City of Ryde Submission

Modification 1 Wicks Road Construction Support Site SSI-8863-Mod-1

(Modification to include 160 Wicks Road as support site

Submission Date: 22 November 2022

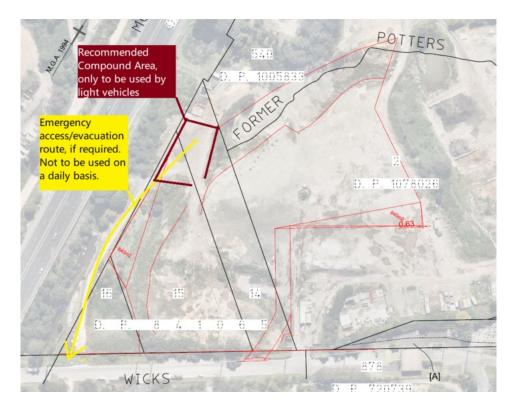
- Flooding : The proposed construction support site area is understood to be outside the 1in100 yr Flood Extent, as indicated on the figure below extracted from Council's mapping system. Any activity/stockpile runoff to flood waters must be mitigated.

Culvert under the site: Site usage plan is to show the exact position of the culvert including any inlet structures. With reference to the figure below, the secondary route marked yellow passes over the old culvert at its shallowest points, therefore, the use of this route must be limited to emergency use only, such as site evacuation. It should not be used on a daily basis by heavy vehicles. A pre and post construction dilapidation report on portions of the Mainline culvert lying beneath the lease area, including both CCTV images and video, will be required to be submitted to Council. Any damage is to be repaired. A Noise & Vibration Plan is to include measures to protect the integrity of the culvert. The area outlined brown below is an area where stockpiling should be avoided. Other uses of the area marked brown, such as a site compound or light vehicle parking, is suggested.
